AMENDMENT OF SOLICITATION/MODIFICATION OF CONTRACT

(X) 9A. AMENDMENT OF SOLICITATION NUMBER
140R2026Q0079

ITEM NO. (A)	SUPPLIES/SERVICES (B)	QUANTITY (C)	UNIT (D)	UNIT PRICE (E)	AMOUNT (F)
	The Solicitation cited in block 9A above, Lake Berryessa East Side Road Fence Repairs is hereby amended. Purpose: The purpose of this amendment is to incorporate the attached revised Statement of Work. The date and time for receipt of offers is hereby UNCHANGED and remains July 2, 2026, at 12:00 p.m. The offeror must acknowledge this amendment by submitting a signed copy of this SF30 along with their proposal.

Lake Berryessa East Side Road Fence Repairs

BARBED WIRE DETAIL

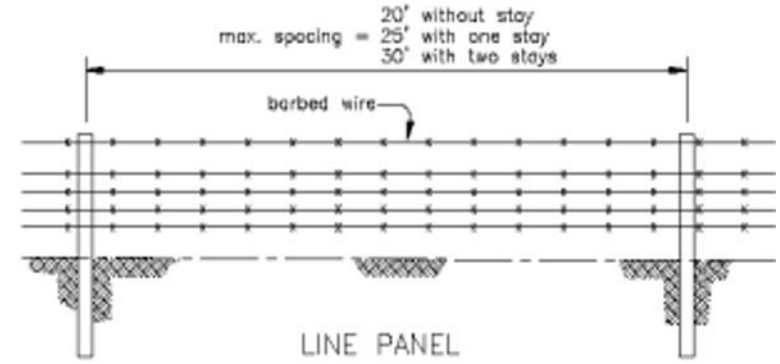
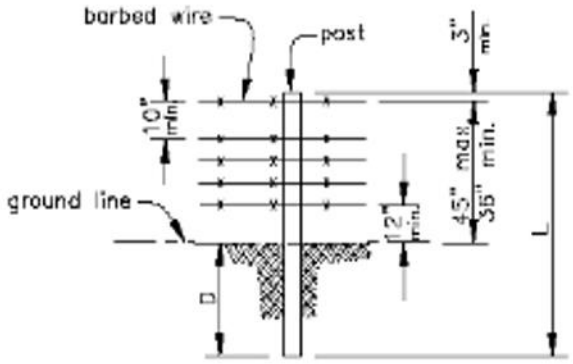
Wire Spacing: When measured from the groundline, a 5-strand fence will locate wires at 5 inches, 12 inches, 20 inches, 30 inches, and between 42-45 inches. ***Where existing fencing is 4-strand, wire spacing must follow the existing layout and conform to NRCS standards for 4-strand designs.***
